Addendum Number: 02

Addendum Issue Date: April 21, 2026

Project Name: CMH – Consulting Clinic Expansion

Project Number: 02500690.001

M3.2

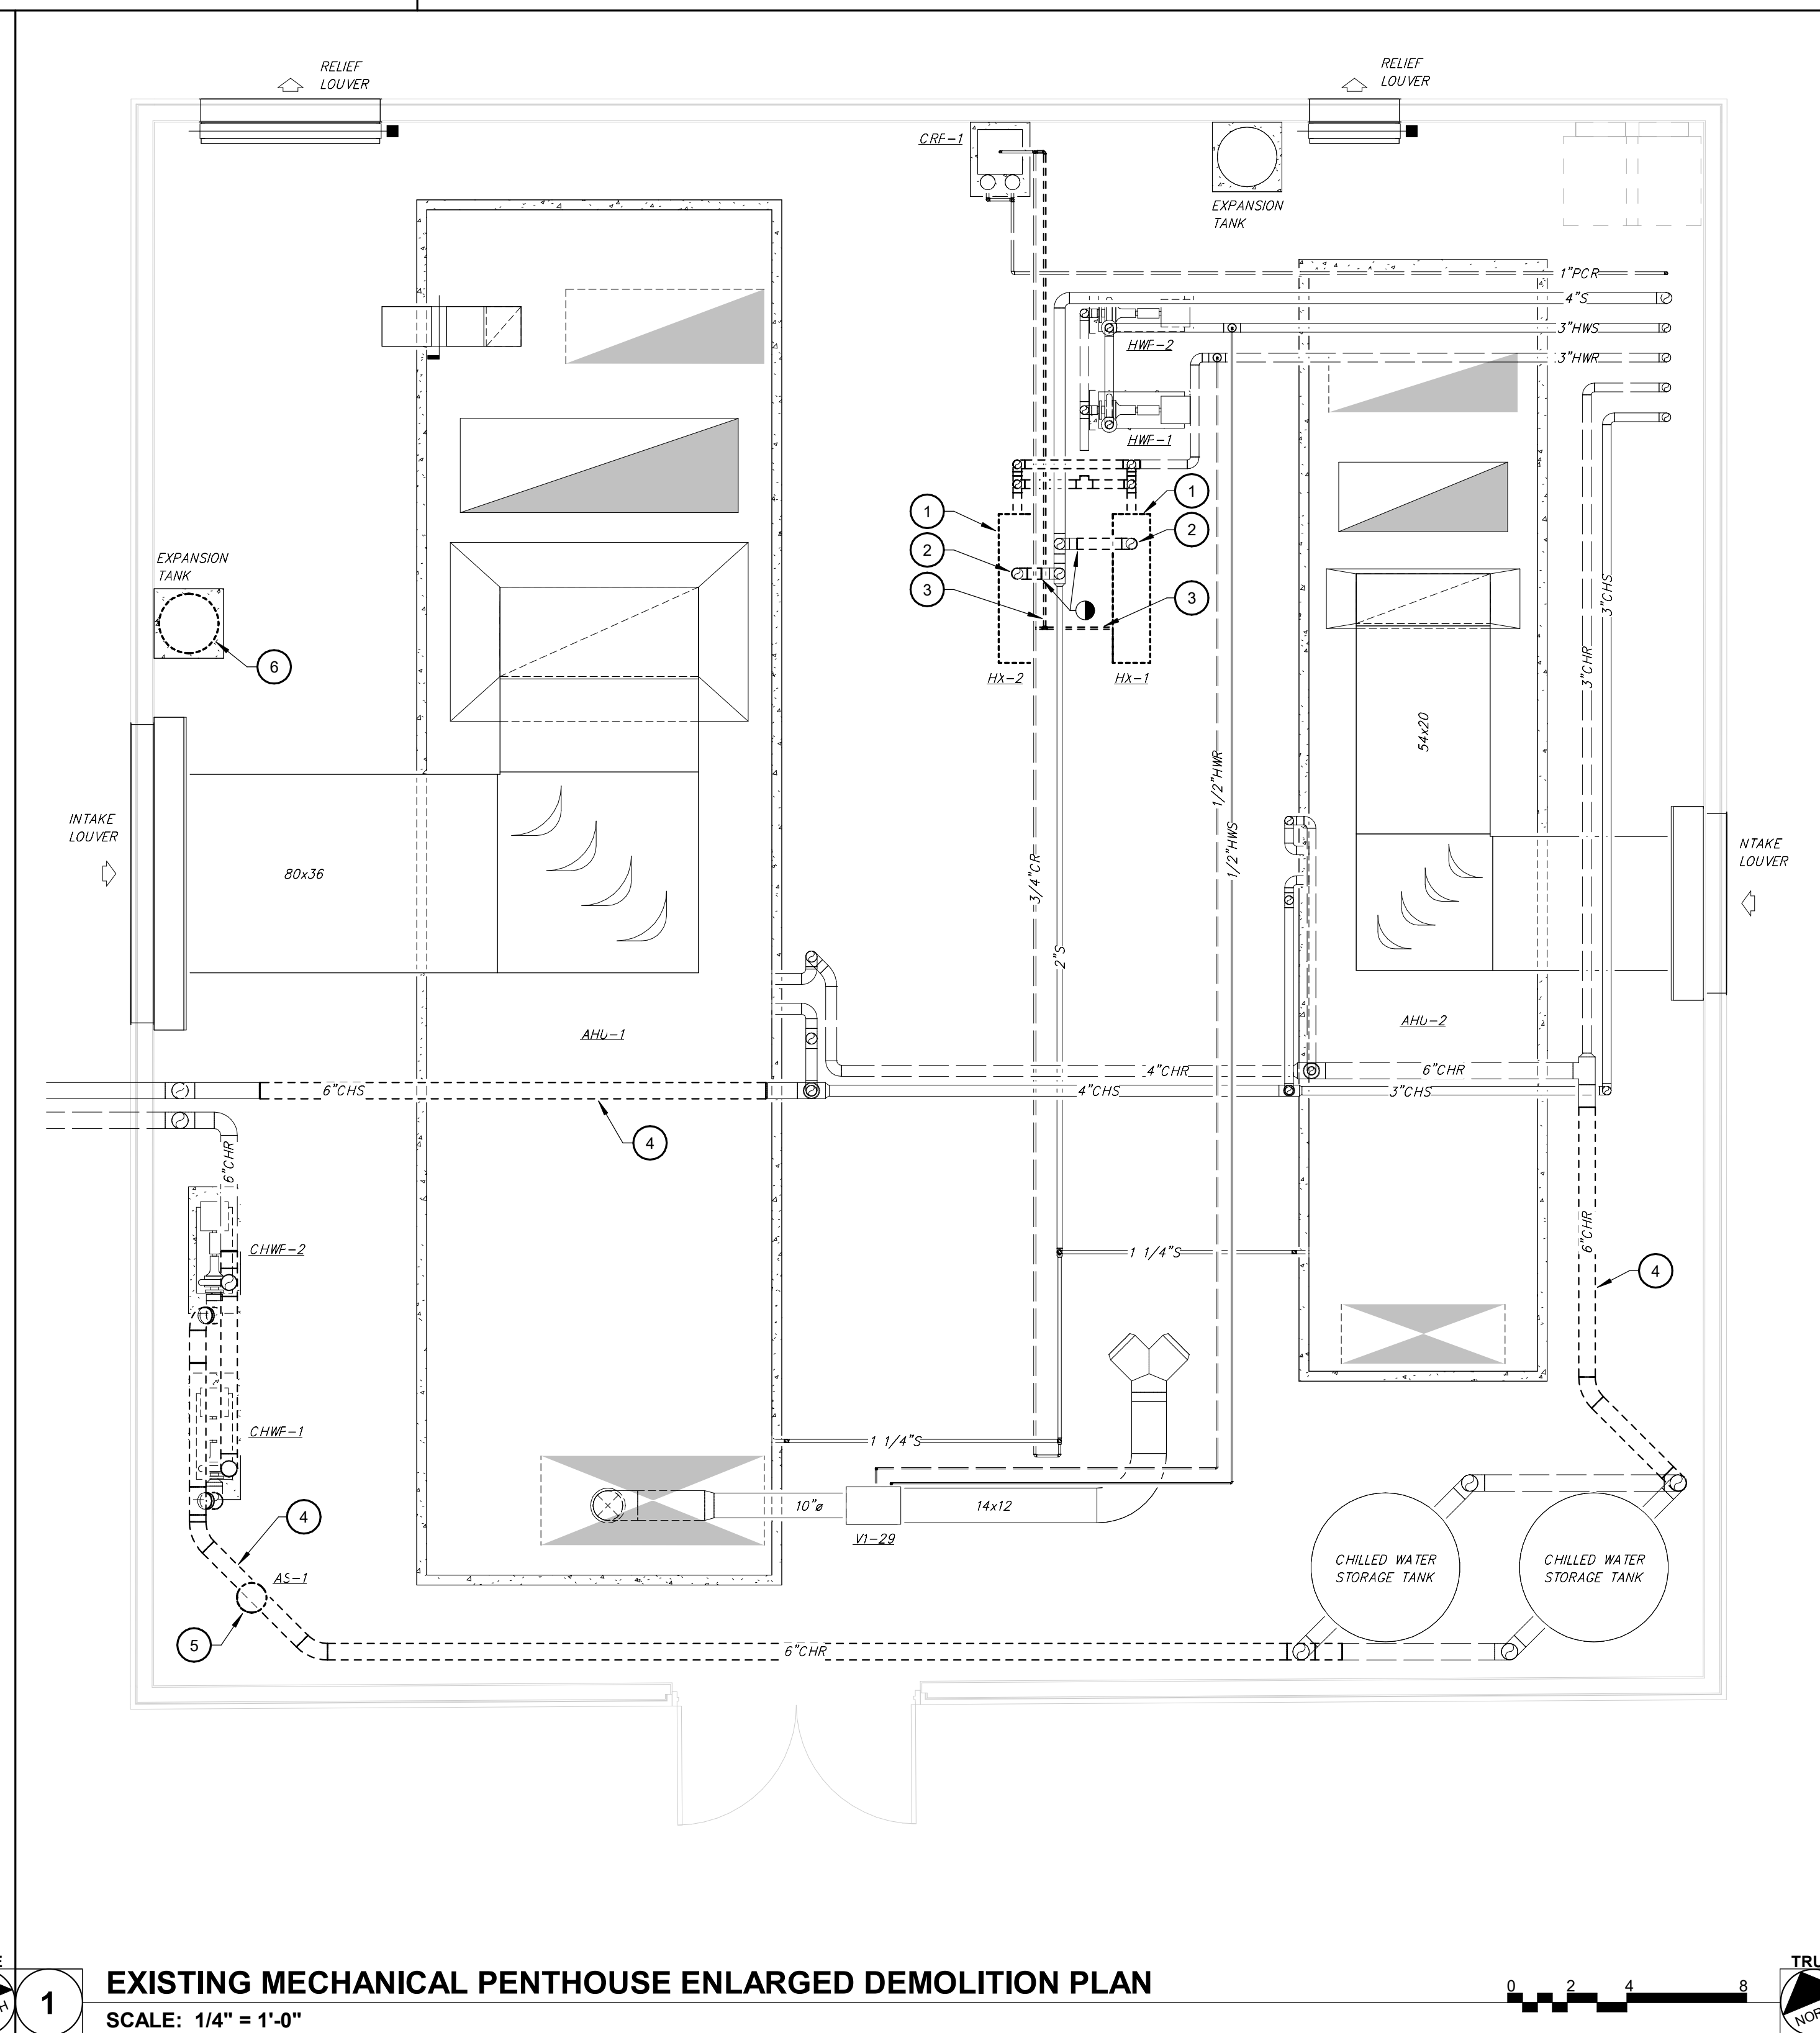
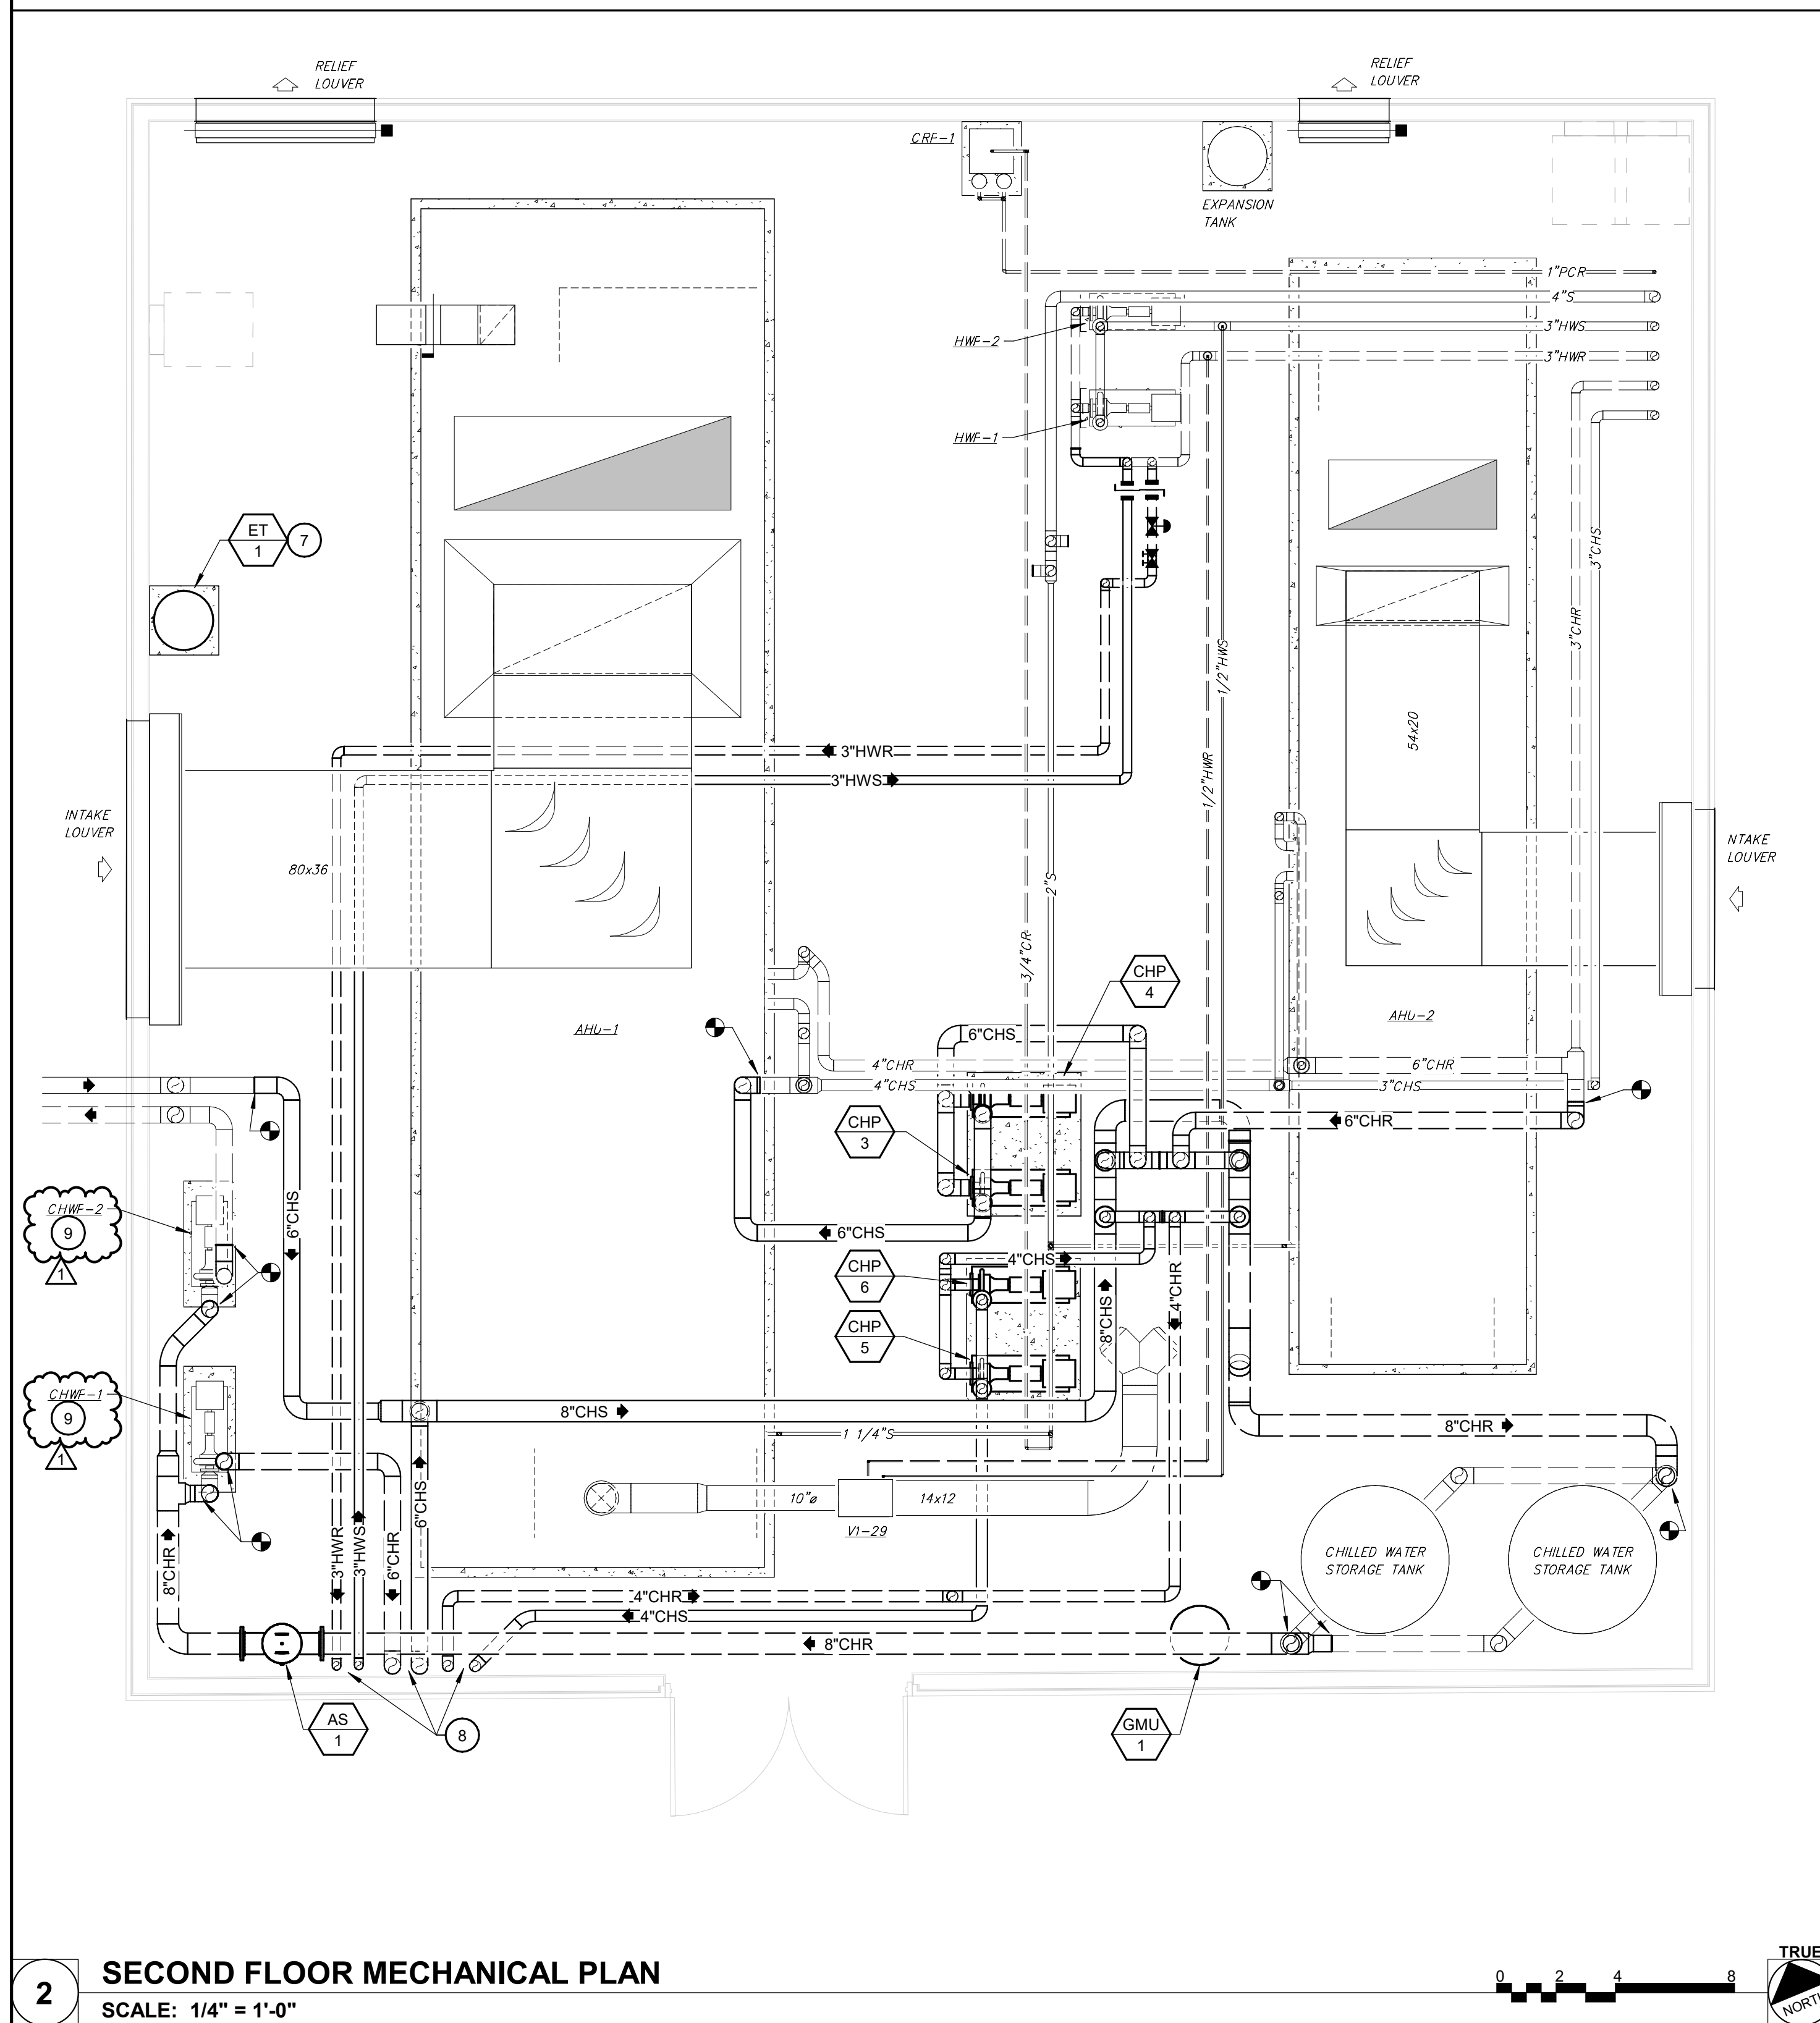
1. Sheet A7.3 – DOOR SCHEDULE
 - a. REVISE door width of SC112-2 to be 4'-0" in lieu of 3'-8" as shown.
2. Sheet M3.1 – ENLARGED PLANS
 - a. ADD motorized dampers serving louvers L-1 and L-2 in first and second floor mechanical rooms. See new keynotes 7 and 8 for clarification.
3. Sheet M3.2 – ENLARGED PLANS
 - a. REVISE keynotes 1, 4, 5, 6, and 8 as shown for clarification.
 - b. ADD keynote 9.
4. Sheet M5.3 – DIAGRAMS
 - a. REVISE Heating Water Flow Diagram – Primary/Secondary to ADD heat exchanger isolation valves as indicated on attached M5.3.
5. Sheet M5.4 – DIAGRAMS
 - a. REVISE Diagram as indicated on attached M5.3.
